WORKING PAPER 6
FAA PROJECT COORDINATION

MAY 2023
VERSION 1.0
DRAFT

Prepared by RS&H for the
Chisholm Hibbing Airport Authority

6.1 FAA PLANNING REVIEW AND COORDINATION

FIGURE 6-9
TAXIWAY A ALTERNATIVE 2

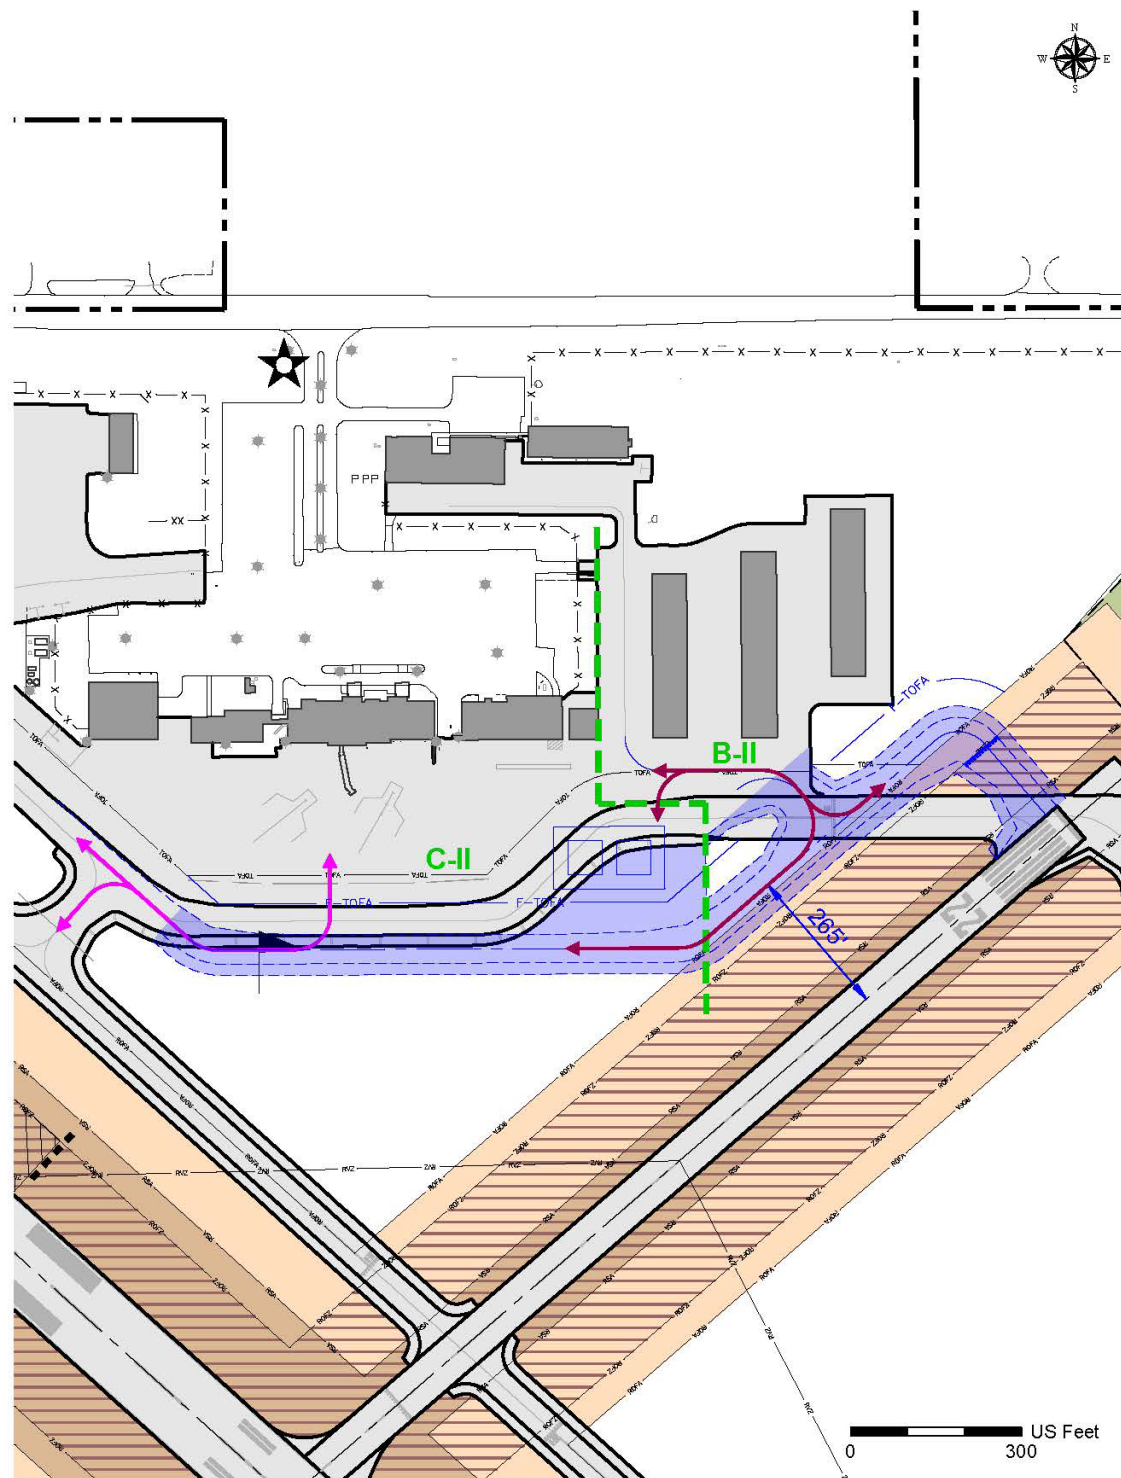
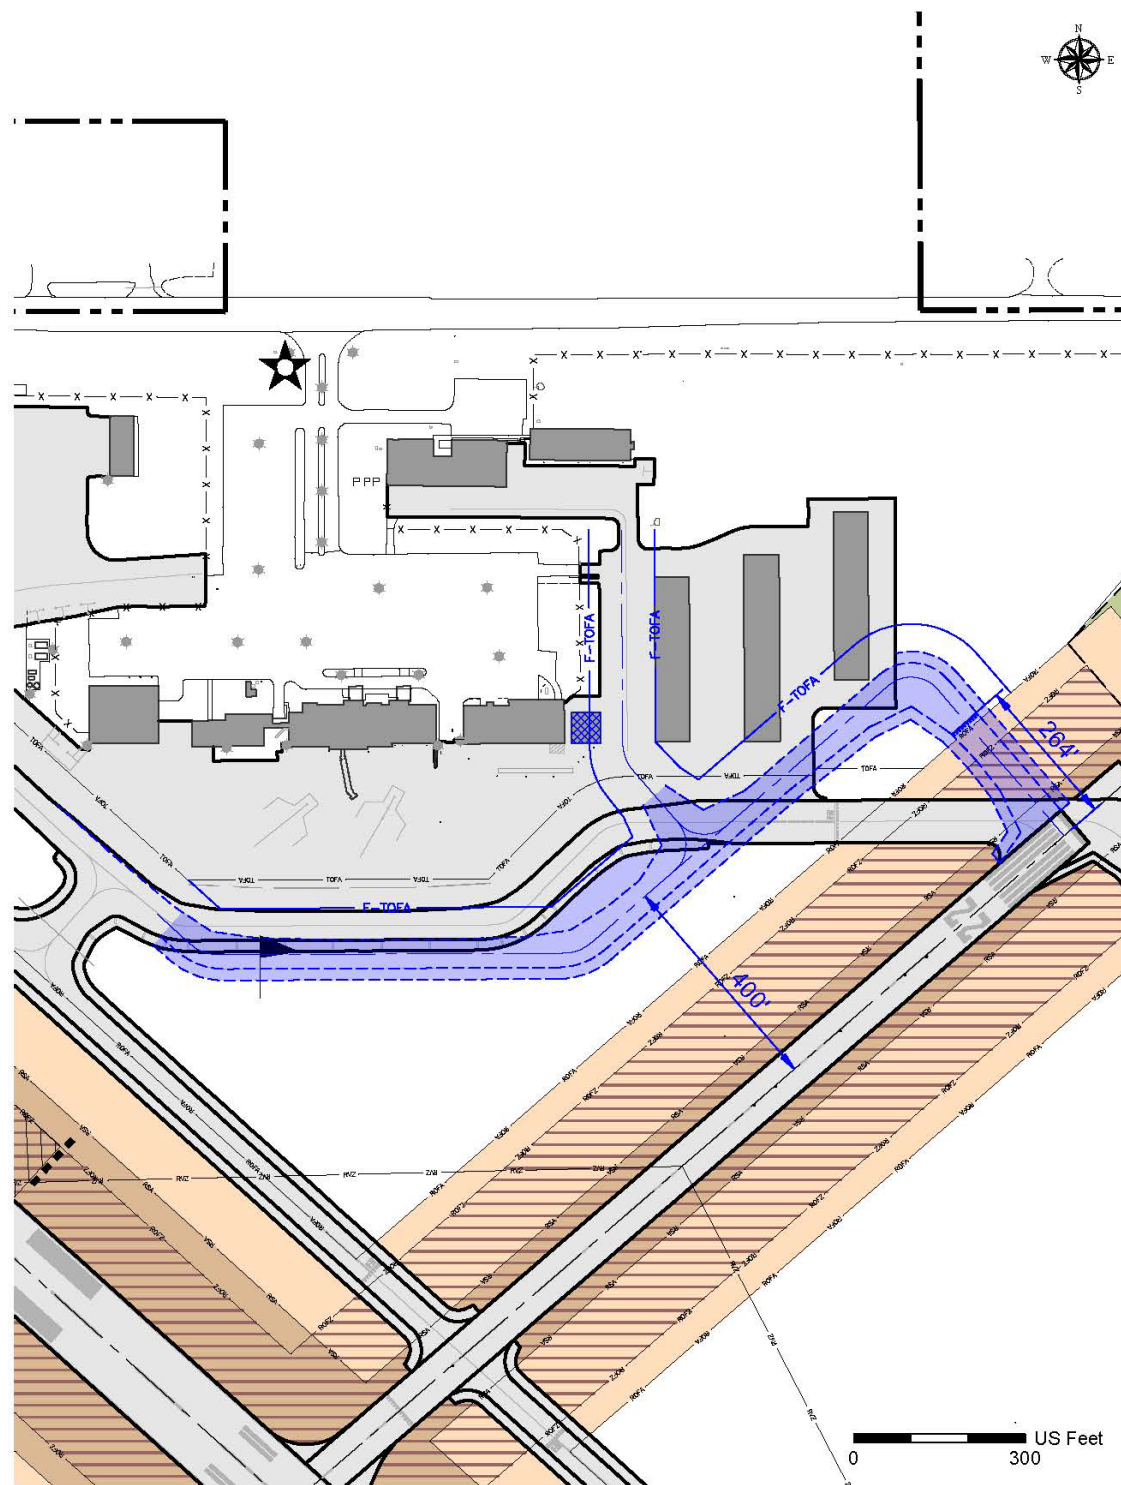
- » Expansion of alternatives to address Runway 13-31 ROFA impacts
- » Expansion of alternatives to address/clarify 'Airfield Pavement Design and Construction Phase I' project purpose, need, and justification
- » Incorporation of apron tie-down configurations

- » Bring portions of taxiway not currently meeting FAA design standards into compliance to promote safe operations. Design standards need to meet the aircraft categories served.
- » Provide adequate safe space for the movement of aircraft along Taxiway A without impeding safe operations/activities in the commercial terminal area, especially during deicing operations performed at the terminal apron perimeter.
- » Replace degraded pavement with low PCI rating to prevent unsafe operating conditions related to failing pavement hazards.

Alternative 2 is the preferred design for Taxiway A improvements under the “Airfield Pavement Design and Construction Phase I” project. This option balances safety with airport user needs based on how the airport facilities are used. Alternative 2 provides necessary parking position to meet near-term need without overbuilding apron space that may go unused once general aviation facilities transition more to the east side of the airport. The same proposed parking spaces provide an opportunity to be later transitioned into a deicing pad.

FIGURE 6-12
EAST SIDE GENERAL AVIATION APRON PARKING POSITIONS

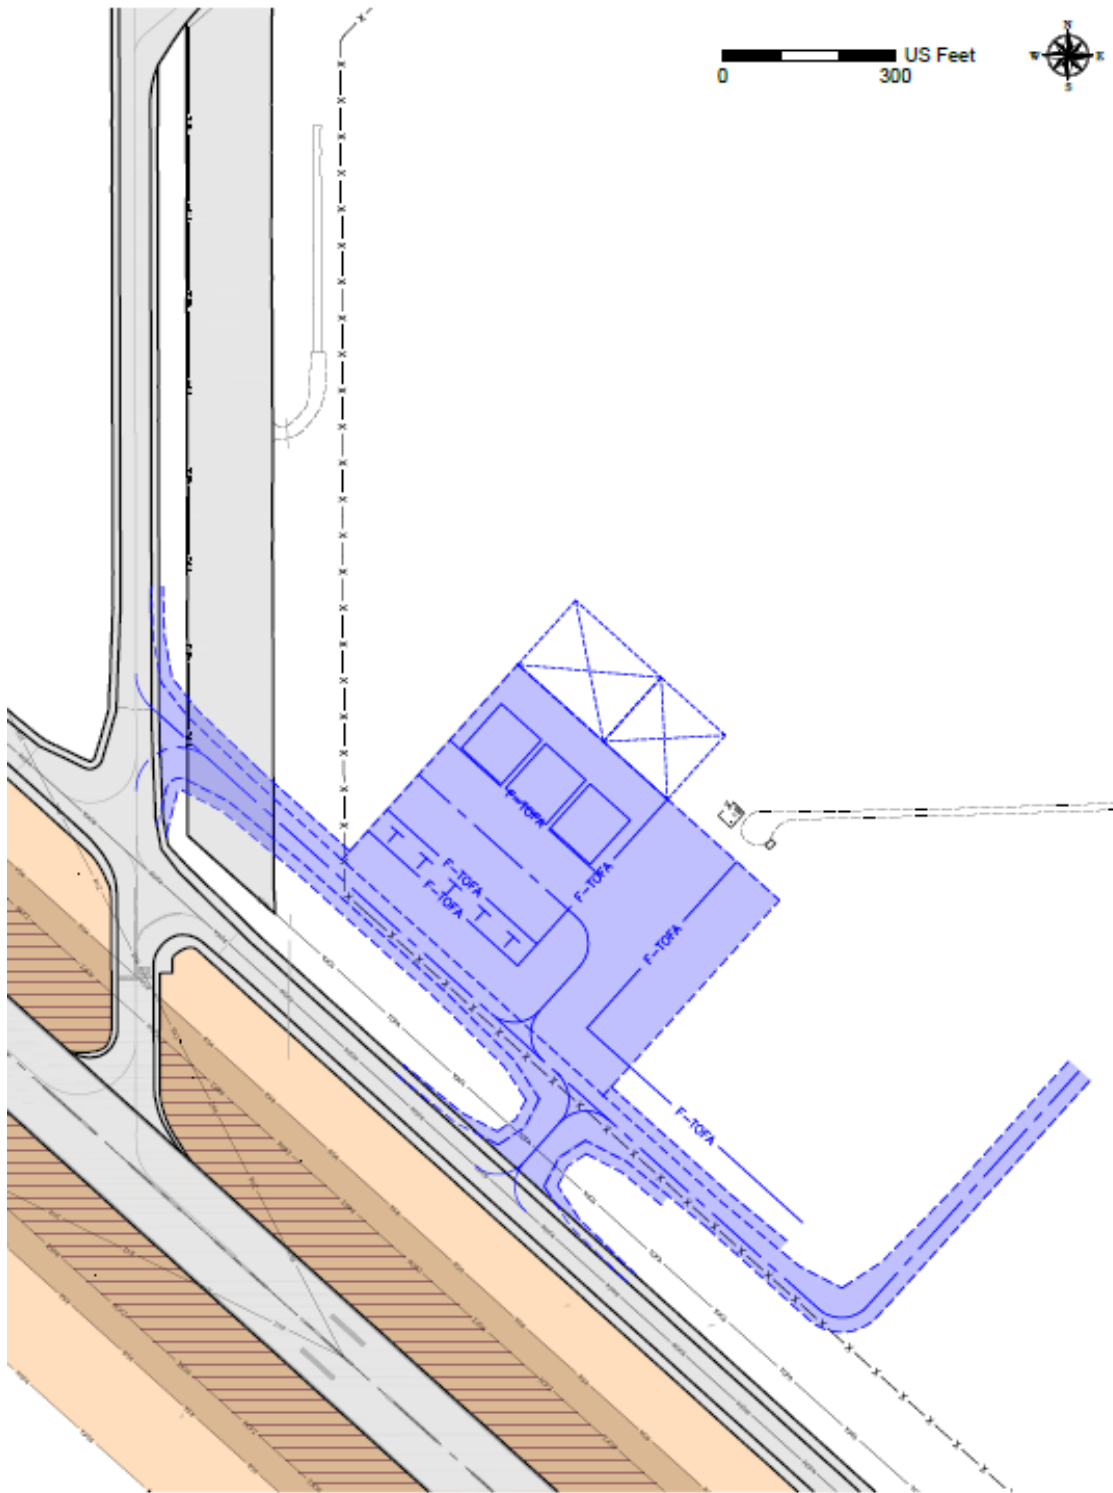
During FAA documentation review, the question was raised, “How many parking positions does the apron space defined in facility requirements accommodate?” Because the types of transient aircraft parking on transient apron can vary widely in size, flexibility was modeled into the space formula based on anticipated fleet use. **Table 6-11** shows the amount of apron space needed over the 20-year planning period to accommodate the corresponding mix of aircraft based on design groups I and II.

With the understanding that transitioning general aviation operations to the east side of the airport will occur over time, **Figure 6-12** shows the initial planned apron and parking position requirements when that development begins. As development of the east side facilities begins, it is recommended that further analysis be done to determine specific apron size and parking position needs.
